SECTION 4.55 PROPOSED SHOP TOP HOUSING DEVELOPMENT

Project PROPOSED SHOP TOP HOUSING DEVELOPMENT

Project Address 9 Sherwood Road, Merrylands

Level 5

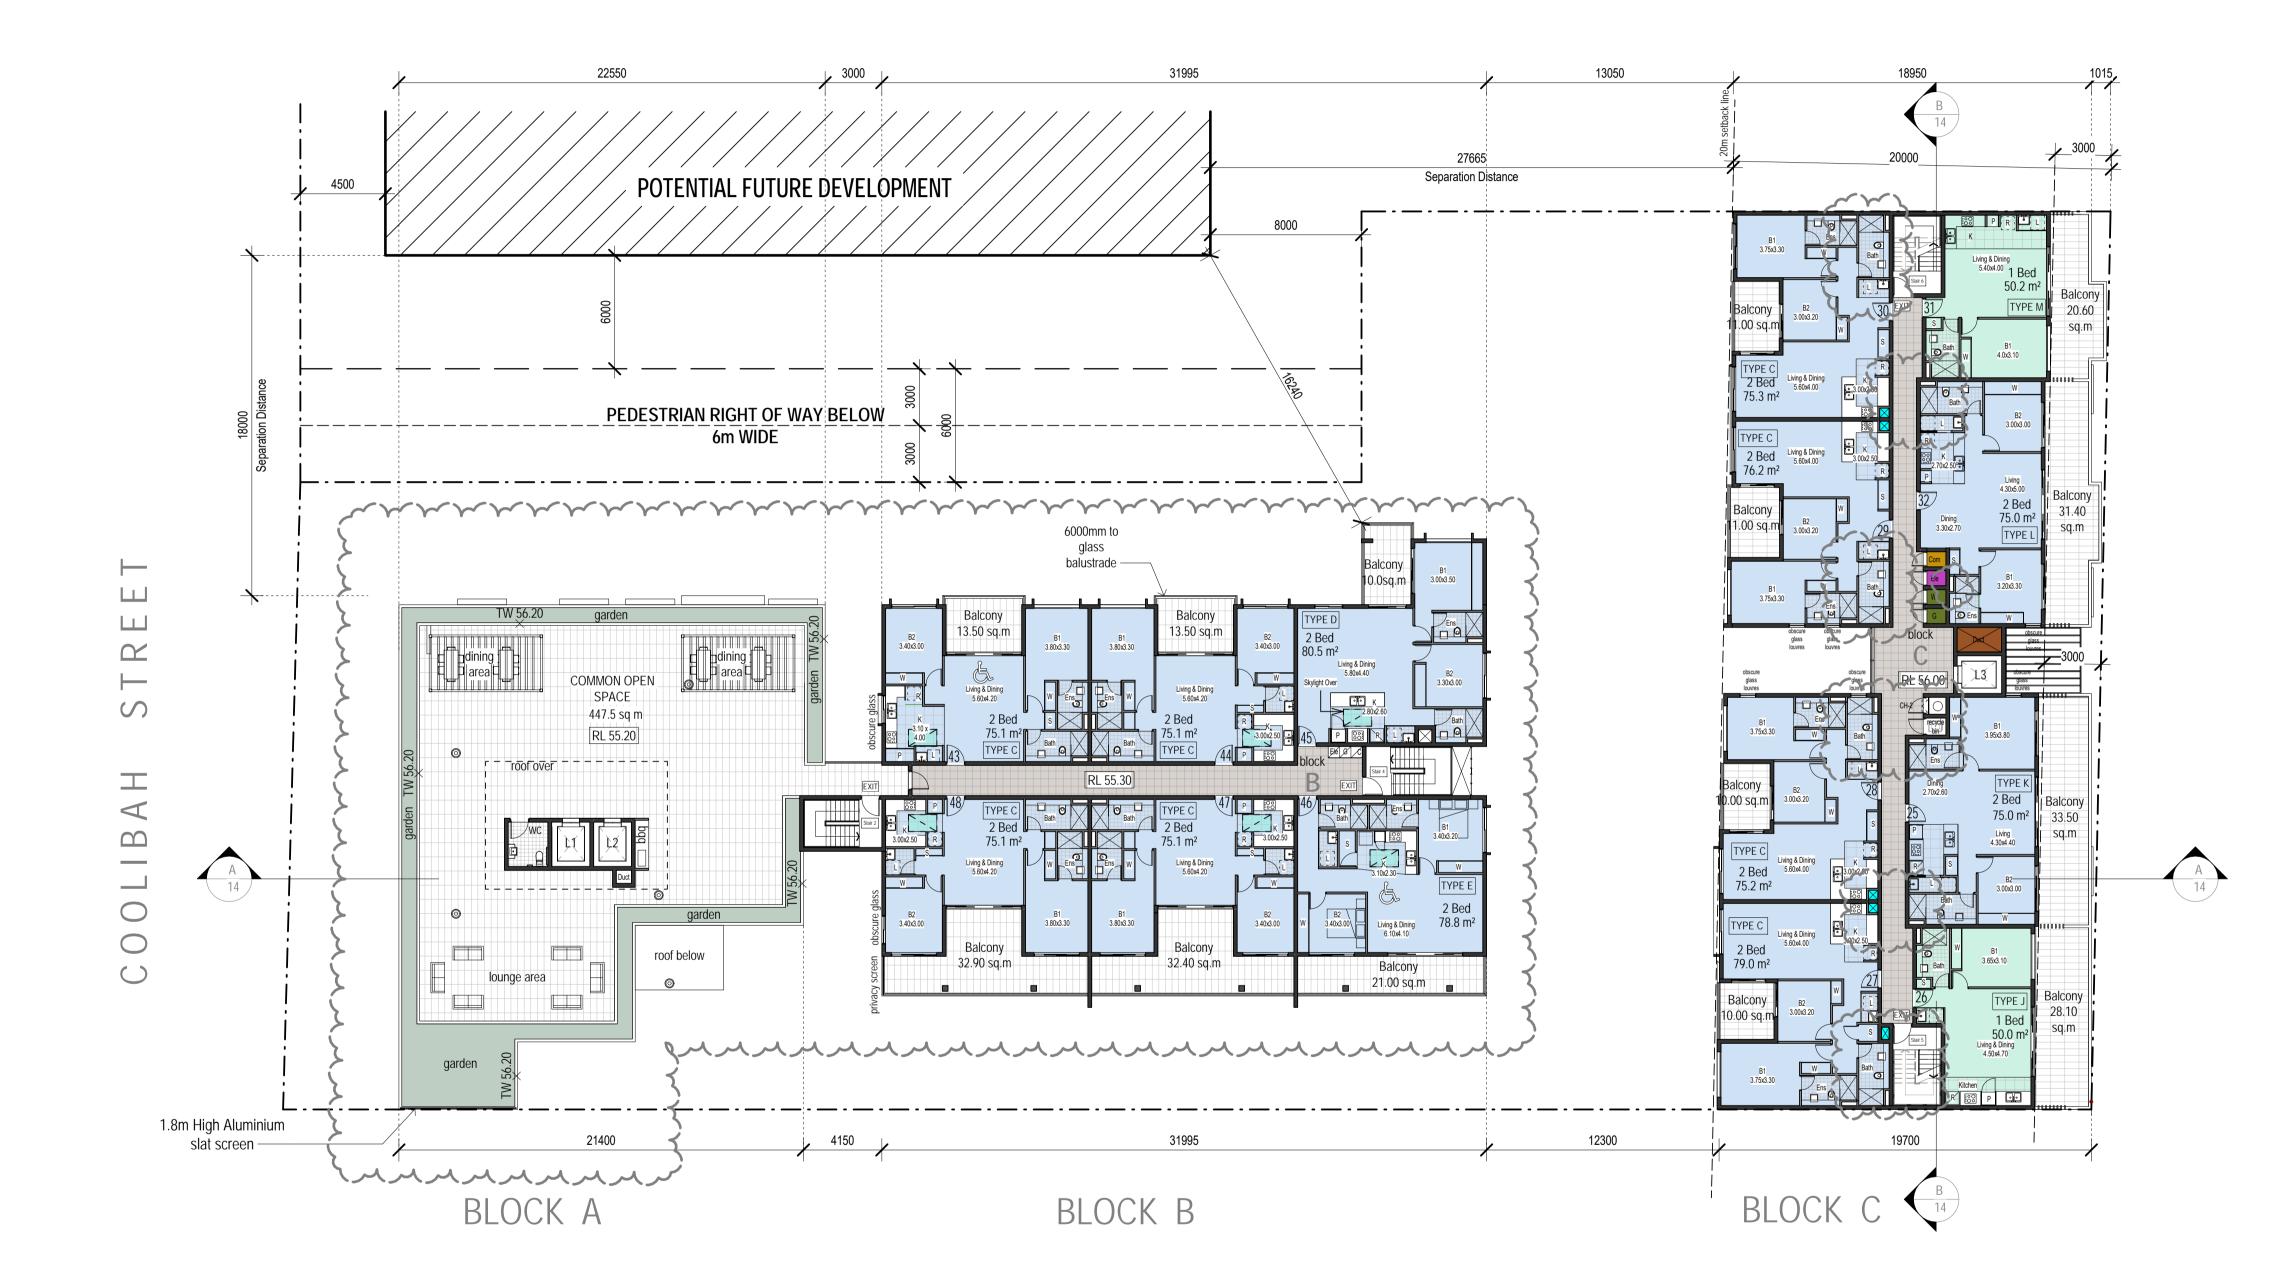
Move Building A+B back to be in 6.0m setback
Corner units in Block A+B amended.

Privacy screen removed from bedrooms and balconies.

Glass louvre windows added for improvements to cross ventilation to all Buildings.

Windows added for improvements to cross ventilation in Block C.
Blade walls reduced to improve Solar

access. - 6.0m setbacks shown on all plans.

-Service Ducts Added - Floor Levels Amended SECTION 4.55

Drawn	Scale	Checked
AS	1:400 @A3	
Job No	Drawing No.	Issue
2220	.08	CC

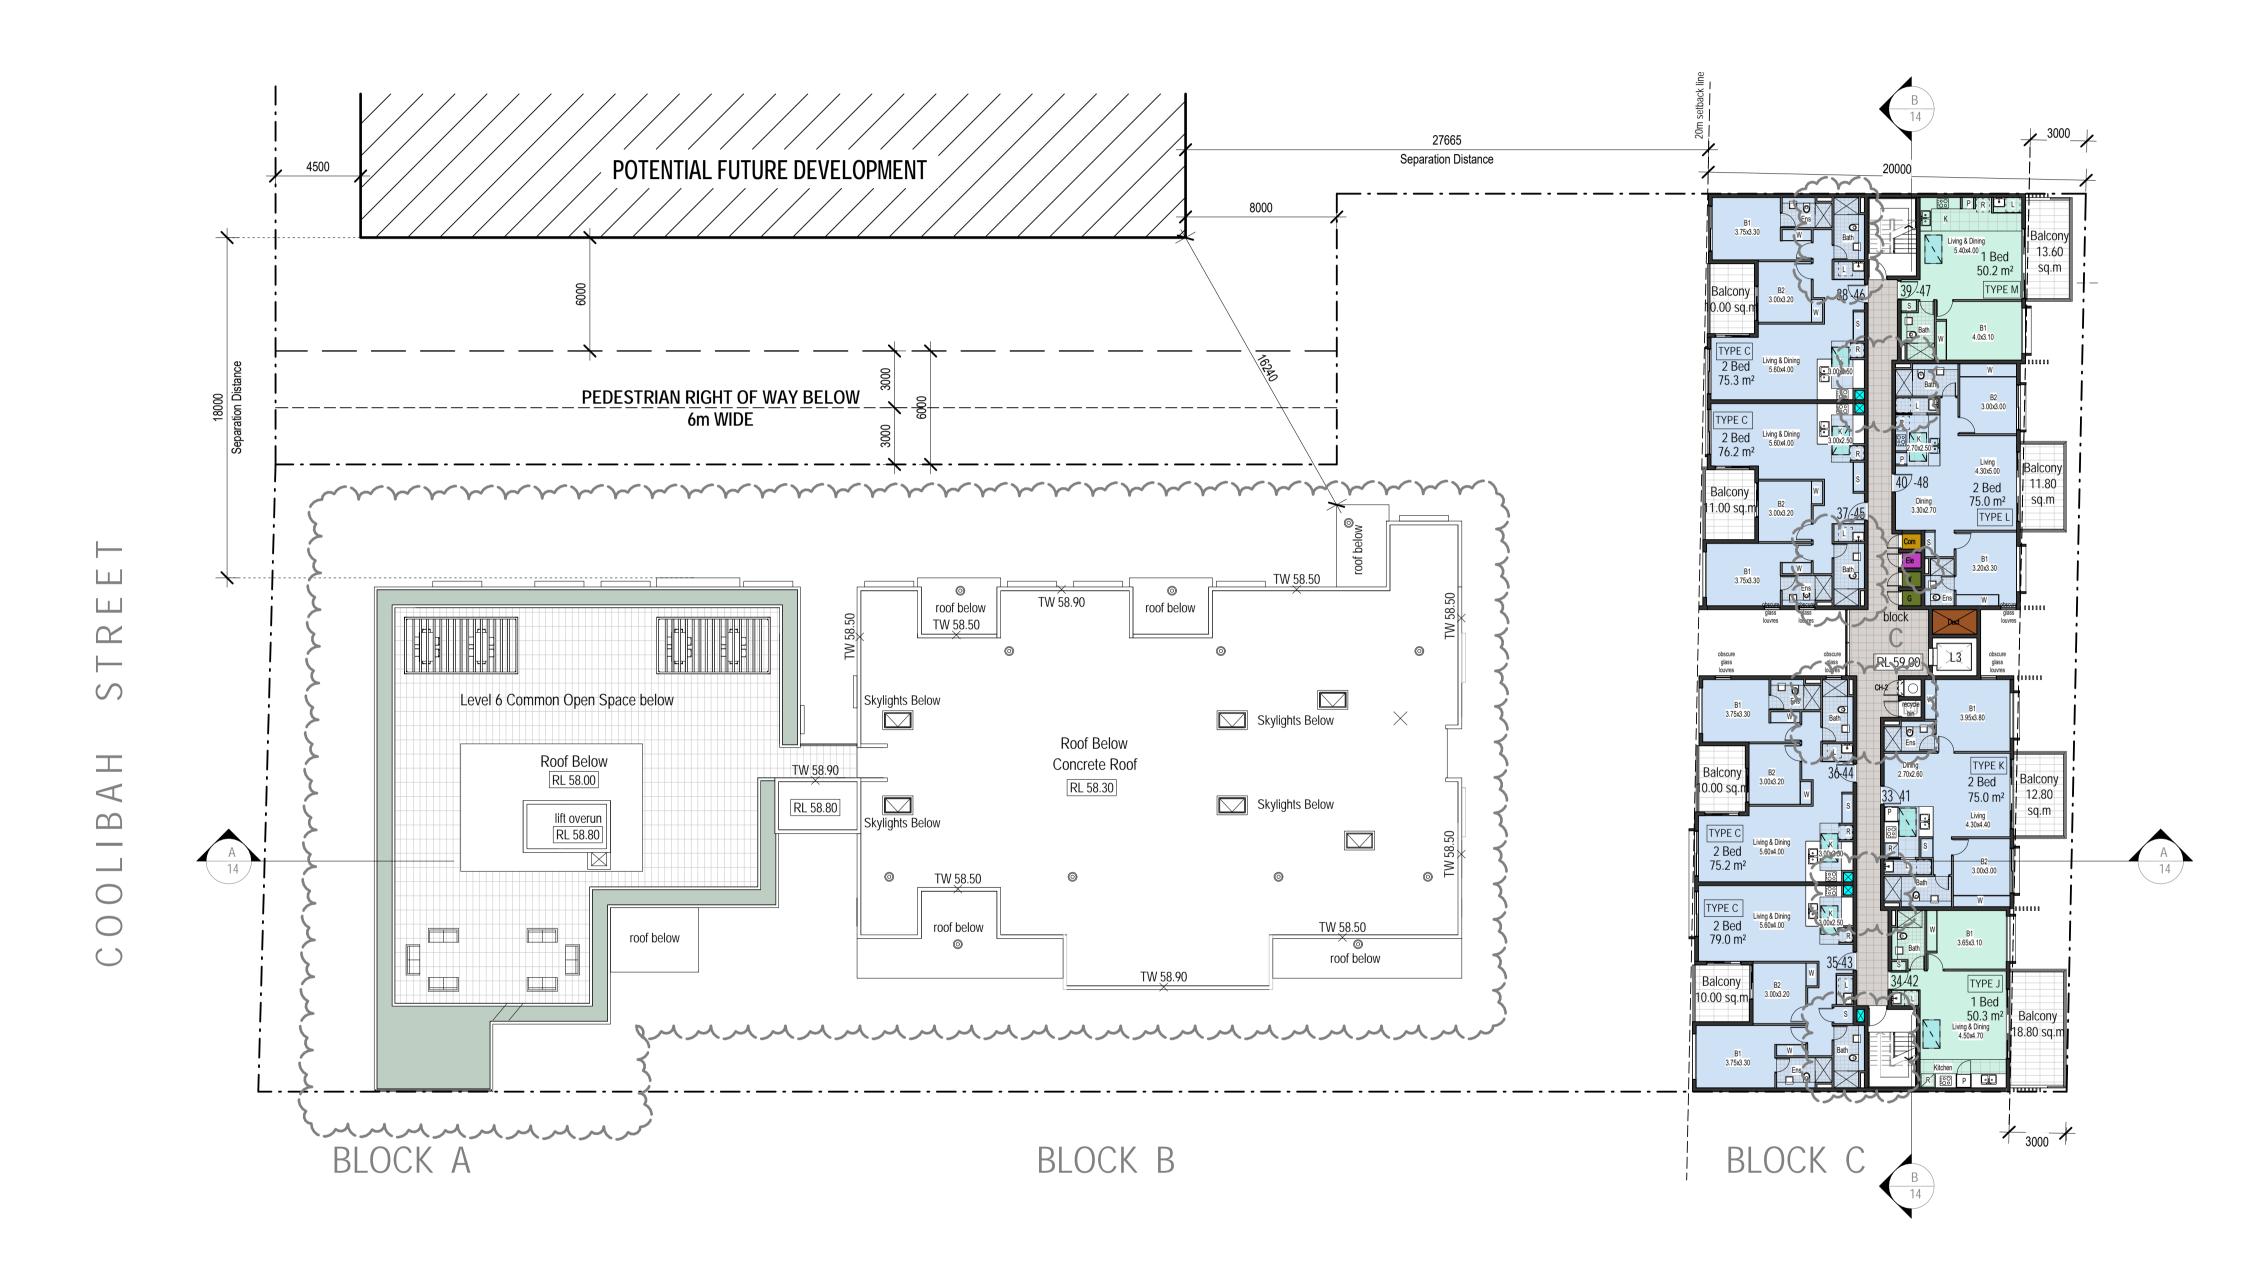
- Move Building A+B back to be in 6.0m

- setback
- Corner units in Block A+B amended.Privacy screen removed from bedrooms and balconies.
- Glass louvre windows added for improvements to cross ventilation to all
- . Buildings.
- Windows added for improvements to cross ventilation in Block C. - Blade walls reduced to improve Solar
- access.
- 6.0m setbacks shown on all plans.
- Common Open space added to
- Block A Roof -Service Ducts Added
- Floor Levels Amended

# Sections - Sewer Pipe Clearance

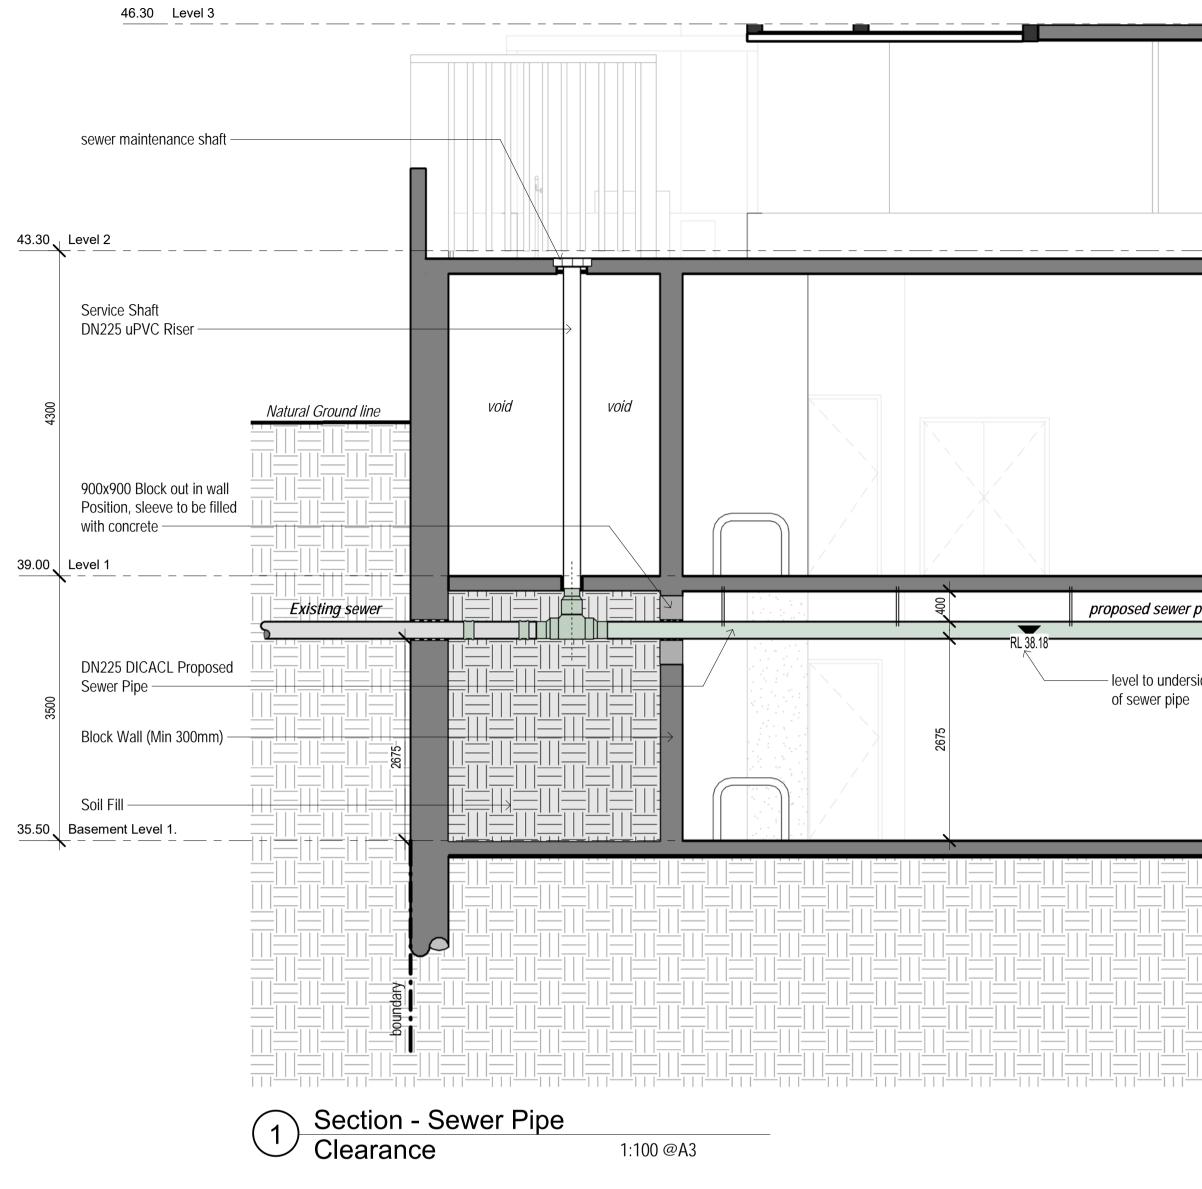
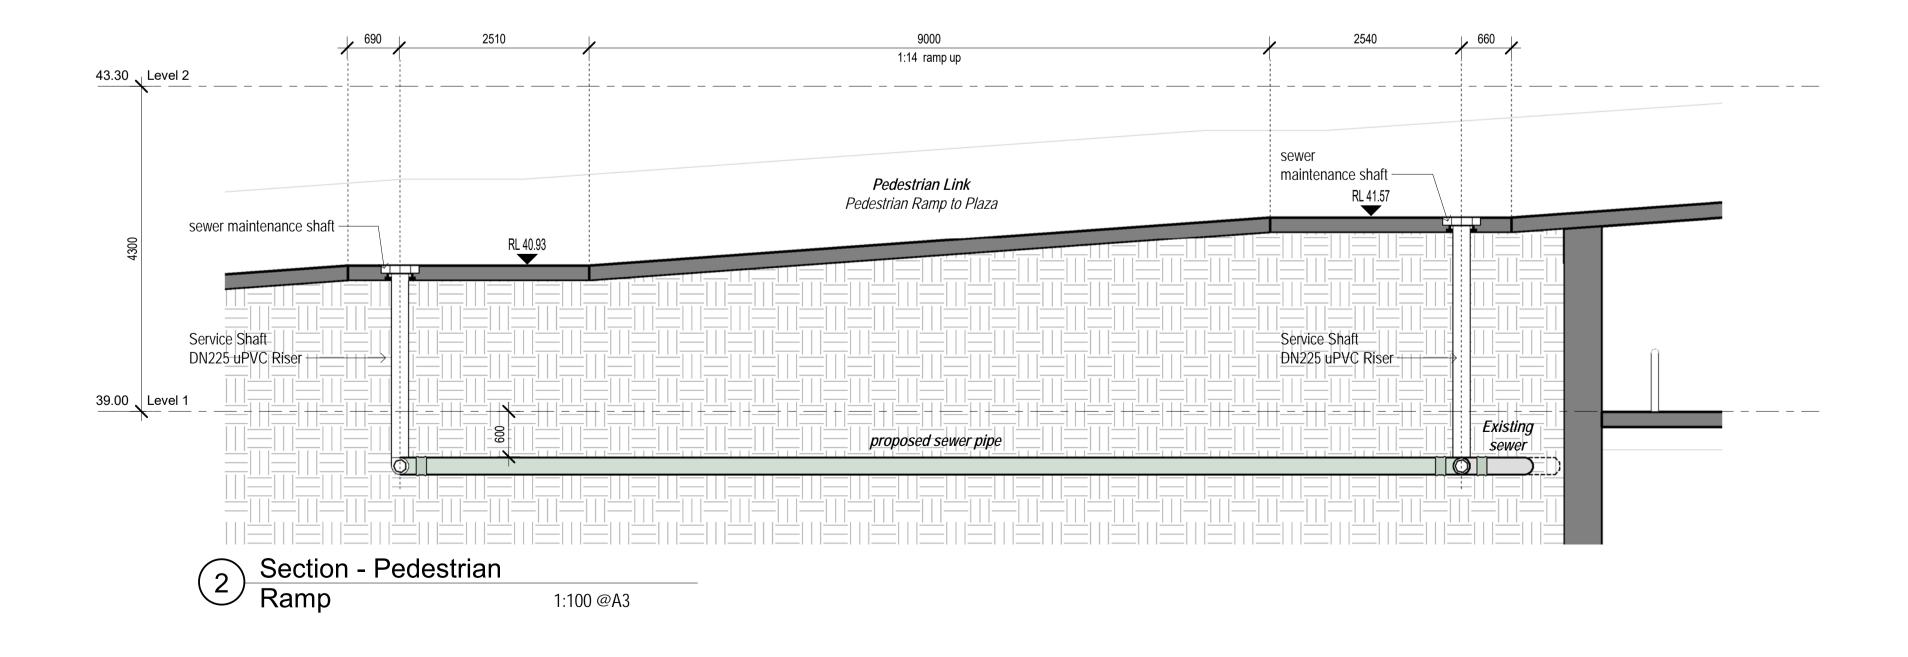
Issue	Issue descrption	Date
Т	Amendments to basement to allow for sewer	09.03.20
Q	Sewer Pipe Details Added	21.02.20
0	Sewer Pipe Amendments	18-12-19
